Subject: Braidwood Unit 2
 Environmental Qualification
 Bunker Ramo Penetration
NRC Docket No. 50-457

Bunker Ramo Instrumentation Penetration
Preliminary Information Submittal

BRAIDWOOD UNIT 2 ENVIRONMENTAL QUALIFICATION EVALUATION
FOR THE BUNKER RAMO INSTRUMENTATION PENETRATION ASSEMBLIES

SUPPLEMENT TO APPENDIX B

Midland II Test Configurations and LOCA IR Values From the Test Log

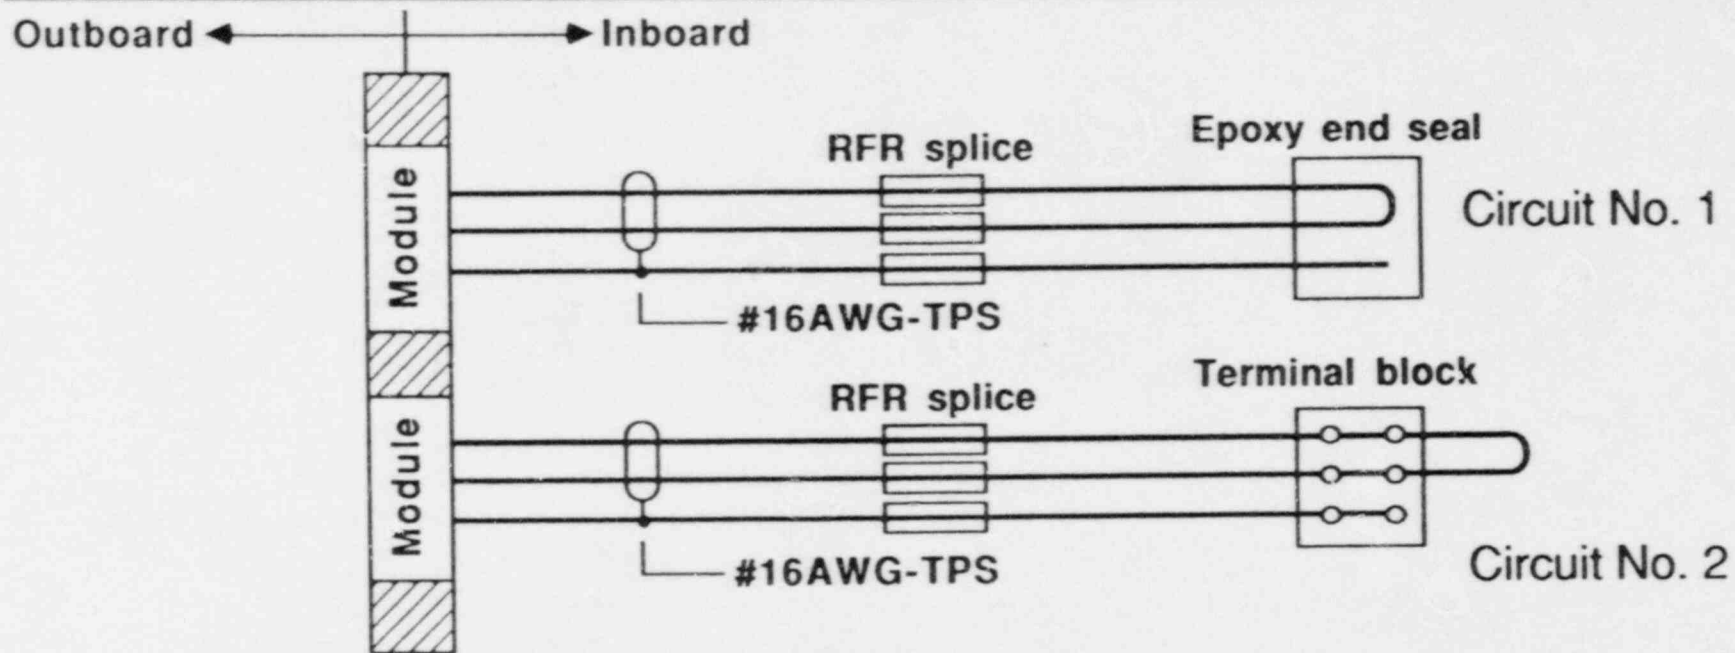
The Midland II test results presented in Appendix B indicate that the minimum Insulation Resistance (IR) recorded during the LOCA, for the #16 AWG instrumentation circuits utilizing the Raychem RFR splices and Epoxy End Seal, was 1.0×10^6 Ohms. This IR value was measured "eight hours into the LOCA" (Reference Page 14 of the Midland II Test Report 123-2201). Based on the Midland II Test Report LOCA profile, eight hours into the LOCA corresponds to 180°F . However, the Braidwood Unit 2 peak LOCA temperature is 320°F . Therefore, what assurance is there that the recorded IR value of 1.0×10^6 Ohms represents the lowest value that may be encountered since it was not measured at the peak temperature of the LOCA profile?

Recorded insulation resistance values (Ohms) during LOCA (#16AWG-TPS only)

Measurement 1	Measurement 2
Circuit No. 1	1.5×10^6 conductor to conductor	4.7×10^6 conductor to conductor
	1.0×10^6 conductor to ground	3.6×10^6 conductor to ground
Circuit No. 2	4.2×10^3 conductor to conductor	1.6×10^5 conductor to conductor
	7.2×10^3 conductor to ground	1.8×10^5 conductor to ground

- THE RESULTS OF THE MIDLAND TEST SUPPORT THE CONCLUSION PREVIOUSLY DRAWN FROM THE BRAIDWOOD TEST THAT THE INSTALLED PENETRATIONS ARE QUALIFIED IN ACCORDANCE WITH 10CFR50.49.
- MIDLAND II TEST MEETS BRAIDWOOD UNIT 2 TEST REQUIREMENTS
- CIRCUITS UTILIZING TERMINAL BLOCKS EXHIBIT LOW IR VALUES
- COMPARISON OF IR VALUES OBTAINED FROM SPLICES VS THOSE FROM TERMINAL BLOCKS DEMONSTRATE THE INTEGRITY OF THE PENETRATION MODULE ITSELF
- BRAIDWOOD UNIT 2 WCSF-N SPLICES SHOULD YIELD BETTER IR VALUES THAN THE RFR SPLICES IN THE MIDLAND II TEST
(i.e. RFR SPLICES DO NOT PROVIDE AN ENVIRONMENTAL SEAL, THE WCSF-N SPLICES DO)

Braidwood Unit 2 Bunker-Ramo Penetration Heat Transfer Model

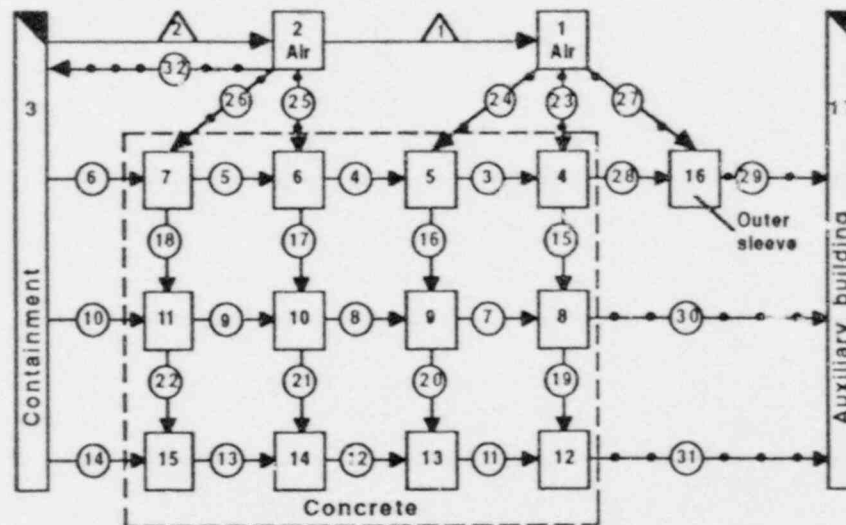
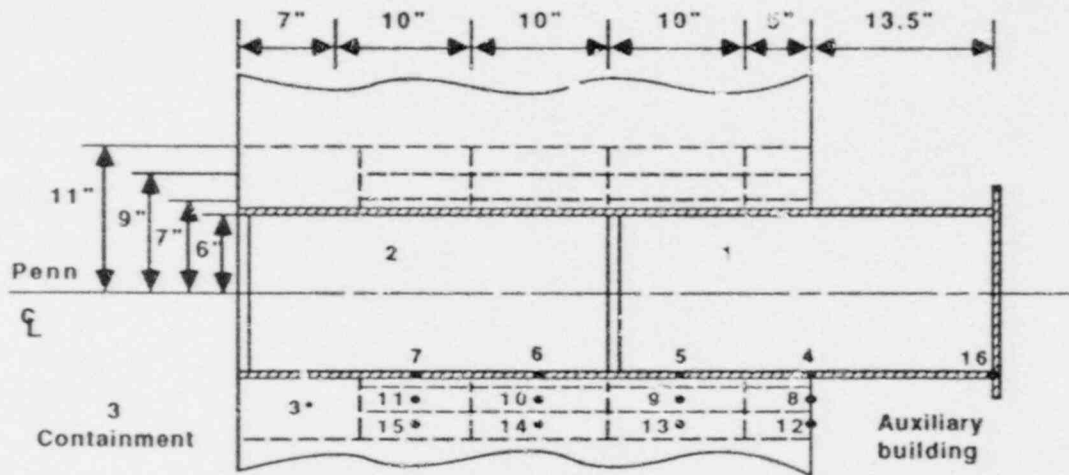
1. NRC QUESTION

To evaluate the effect of the accident temperature pressure transient on the feed through module, a computer model of the containment and the penetration was prepared. The first node in the model was the area between the center support plate and the closure flange of the penetration. The feed through module is partially exposed to the environment in this node. The second node in the model was the portion of the penetration assembly between the inboard support plate and the center support plate. The third node in this model was the containment volume. The nodes communicate with each other by means of the openings in the support plates. The model also accounts for heat transfer into the surrounding steel and concrete and into the Auxiliary Building Electrical Penetration area. A diagram of the model is given in Exhibit B-1.

Braidwood Unit 2 Bunker-Ramo Penetration Short-Term Heatup Curve

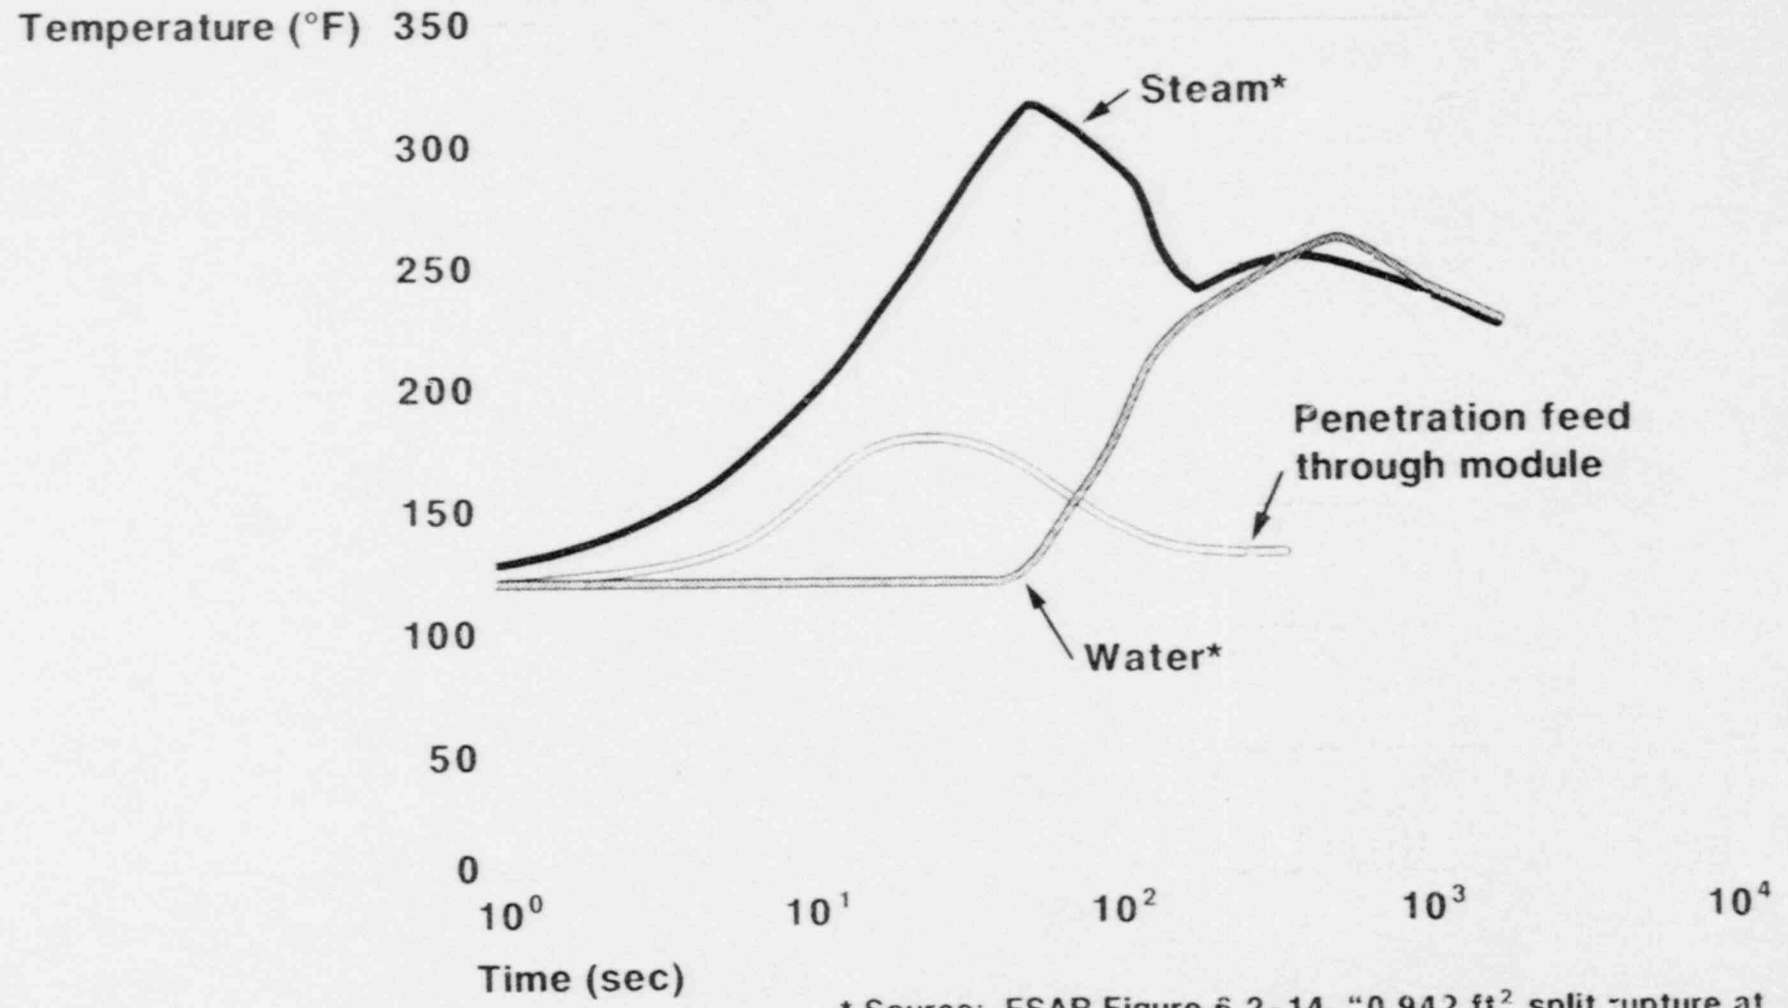
2. NRC QUESTION

The Midland II and Braidwood Unit 2 Test IR values were measured at 500 Vdc. However, the installed Braidwood Unit 2 instrumentation circuit voltage is 40 Vdc. Demonstrate that IR measurements at the installed circuit voltage of 40 Vdc would be more conservative than those taken during the test at 500 Vdc.

- B. To provide additional confidence, we have performed calculations indicating that the MSLB peak temperatures will not be seen by the penetrations prior to ESF actuation and during the time frame when the Post Accident Monitoring (PAM) instrumentation would be used. This evaluation documents that the temperatures at the penetration feed through modules will not exceed 200°F prior to initiation of the necessary instrument signals to trip the reactor and initiate safety injection. This evaluation also documents that the temperature at the feed through module will remain at a value well below 200°F during the time frame when the Post Accident Monitoring System (PAMS) is required. This evaluation documents that the temperatures at which the IR values were taken in the Midland II test envelope the anticipated feed through module temperatures during the accidents.

This computer analysis utilized the Westinghouse mass-energy release data and the containment pressure - temperature curves from FSAR Chapter 6 to establish the time dependent conditions in Node 3. Using this input, the time history of the pressure/temperature conditions in Nodes 1 and 2 was calculated. Exhibit B-2 shows the temperature on Node 1 (adjacent to the feed through module) plotted on the containment temperature curve for the Main Steam Line Break (FSAR Figure 6.2-14). It should be noted that the maximum temperature at the feed through module prior to trip initiation (10 seconds) is 151^oF. This temperature is well below the temperature at which the Midland IR value was measured of 200^oF. Because the temperature at the Braidwood penetration feed through module will never exceed the 200^oF value at which the Midland IR test data was taken, the MSLB computer analysis is considered binding for the Main Feedwater Line Break, also. This is based on FSAR Section 6.2.1.4.

Finally, an evaluation of the long term penetration temperature was made. As can be seen from Exhibit B-2, the model predicted that the penetration would return to less than 130°F after approximately 400 seconds. A steady state evaluation is being performed using the longer term conditions to demonstrate that no significant heatup due to convective mixing between the vapors in the penetration and the vapors in the containment was expected in the long term. This evaluation envelops the long term LOCA and MSLB environments. No significant heatup of the penetration due to convection is expected.

In summary, calculations were performed that demonstrate that the temperature rise at the Braidwood feed through modules during the initiation of the MSLB, will not exceed the 200°F temperature where the Midland IR data was collected. This calculation envelops the LOCA and FWLB and demonstrates the actuation of reactor trip and safety injection prior to achieving an excessive temperature. An additional evaluation is being performed to confirm that a long term heat up of the penetration is not expected in the post-accident mode that would potentially affect the post accident monitoring instrumentation. The purpose of this evaluation is to provide further support for the use of the Midland penetration qualification data. The completed evaluation will be summarized and available for NRC review on Monday, March 28, 1988.
